**Curtis H. Stanton Energy Center
Combined Cycle Unit A**

Sufficiency Report

Re: Stanton Unit A Combined Cycle Project
Supplemental Site Certification Application
FDEP File No. PA 81-14SA2
DOAH Case No. 01-0416EPP
OGC Case No. 01-0176
Response to Statement of Sufficiency

Stanton Unit 1 and 2
Stanton A
Water Mass Balances

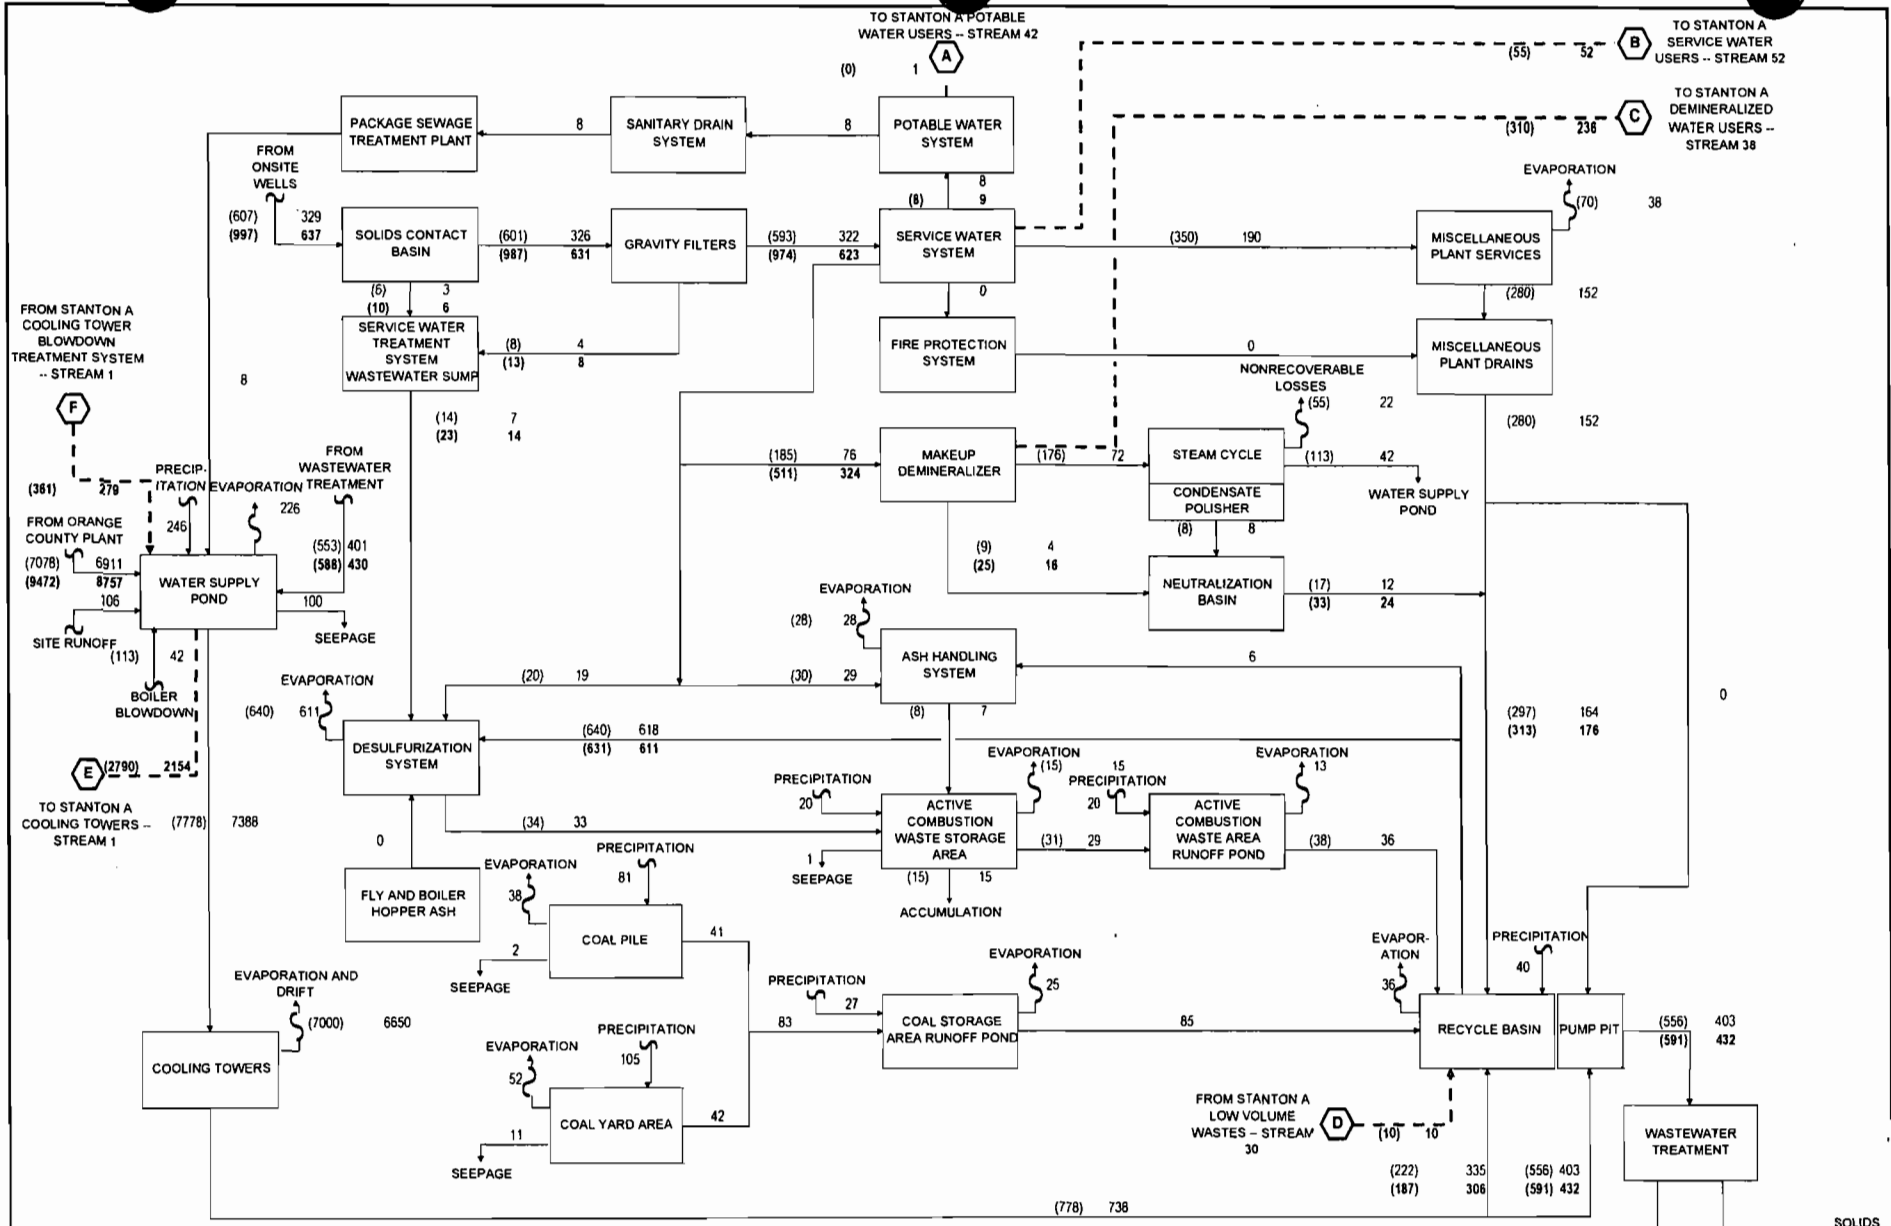
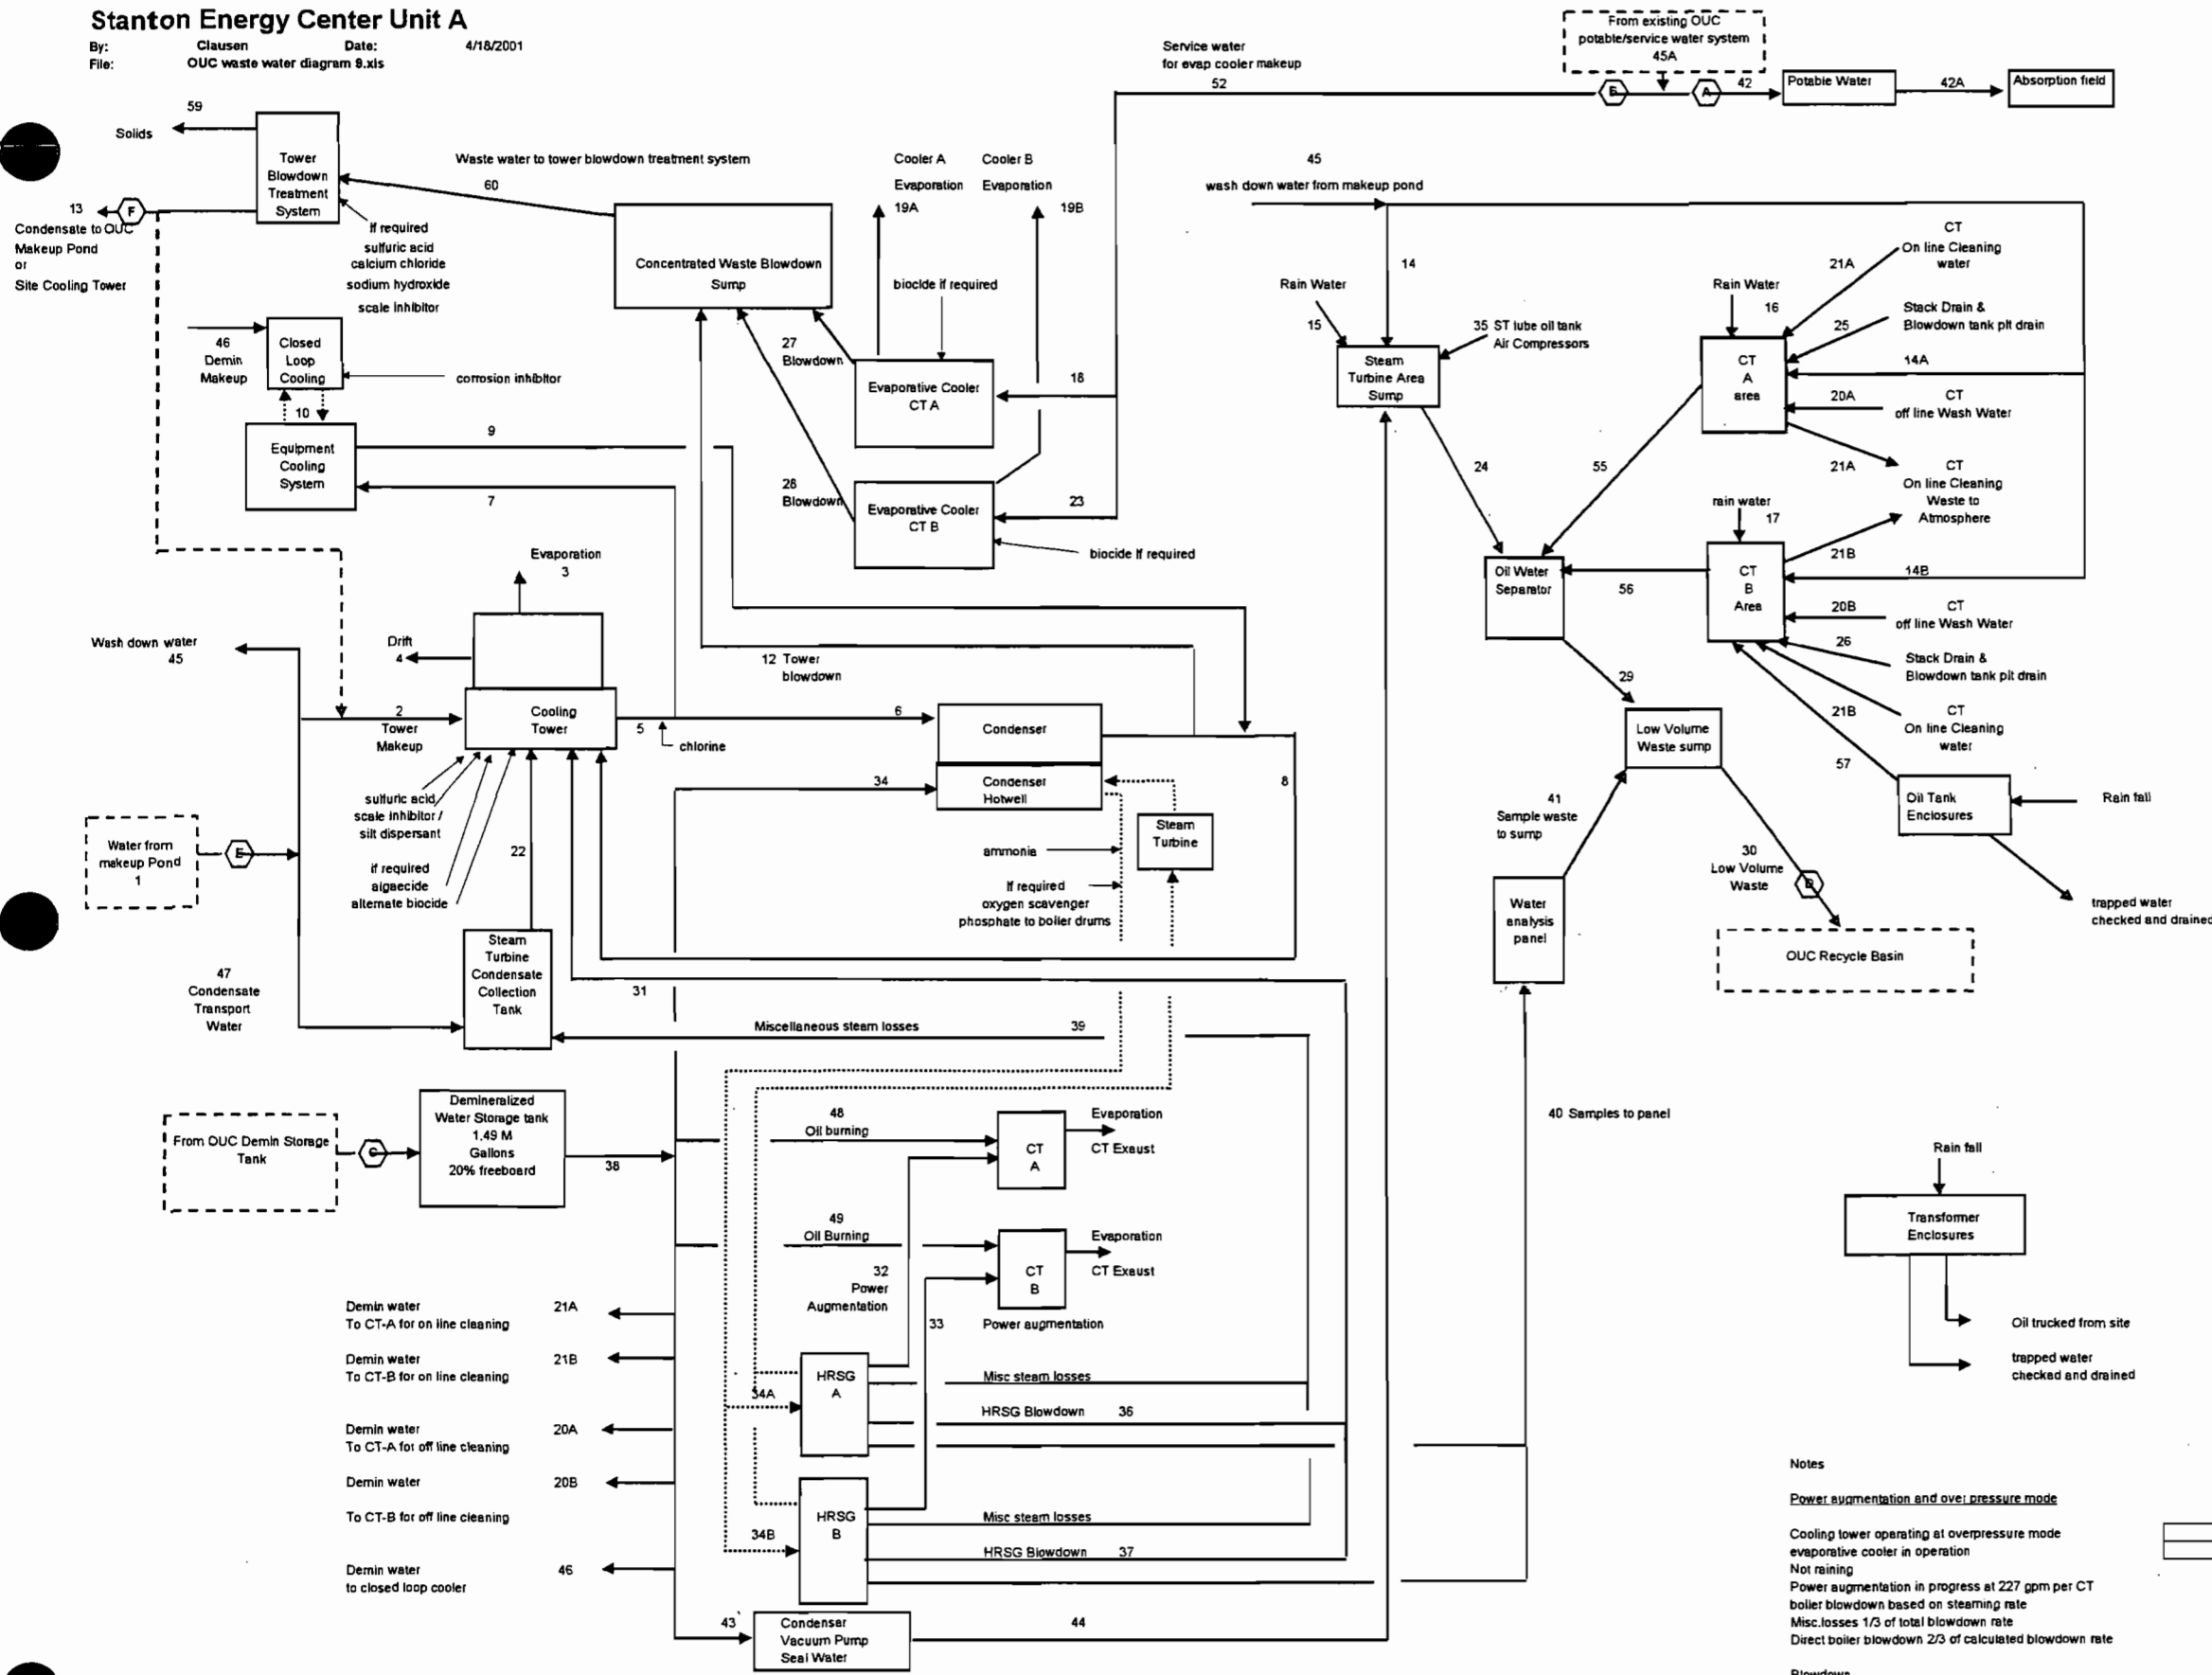
1. *The applicant has provided a single line diagram for the new expansion. This diagram does not show chemical feeds and all treatment systems. Some existing treatment units will be used for the treatment of the wastewater generated from the new expansion. A revised single line diagram for the entire facility (Units 1, 2, and A) showing all treatments units, chemical feeds, and disposal methods is requested. Please show average daily and maximum daily flows for all existing units and the expansion.*

2. *On Figure 3.5-1 (single line diagram), please show final disposition of the treated water and wastewater for "OUC Tower Blowdown Treatment System" (Node 60).*

17. *Please revise the Water Balance (Figure 3.5-1) to include all of the wastewater streams going to the reuse basin and the make-up pond. Please show the recycle basin water going to Gas Desulfurization and Ash Systems and the return effluent, if any.*

Response: The Unit 1 and 2 water mass balance shows the water uses and wastewater systems for the existing facilities and infrastructure. This drawing is based on Figure 3.5-1 submitted with the Stanton Energy Center Unit 2 Site Certification Application and shows all interfaces with new facilities. Water mass balance is attached as OUC waste water diagram, Rev. 9 and shows the chemical feeds, treatment systems, and disposal methods for Unit A as well as interconnections with the existing infrastructure. The attached water balances also include the average daily and maximum daily flows for all 3 units.

Response: The revised water mass balances depict the final disposition of the treated water and wastewater for the cooling tower blowdown treatment system. The distillate from the new Stanton A CTBT system will be recycled to Stanton A's cooling tower under normal operating conditions; it will only be sent to the makeup pond for emergency disposal. The distillate is high quality water and should not affect the use of the makeup pond water or cause any environmental impacts.

Response: The new brine concentrator is illustrated on the revised water mass balance for Stanton A, which is attached. There is no boiler cleaning waste neutralization system at the site. The boiler cleaning contractor will remove the
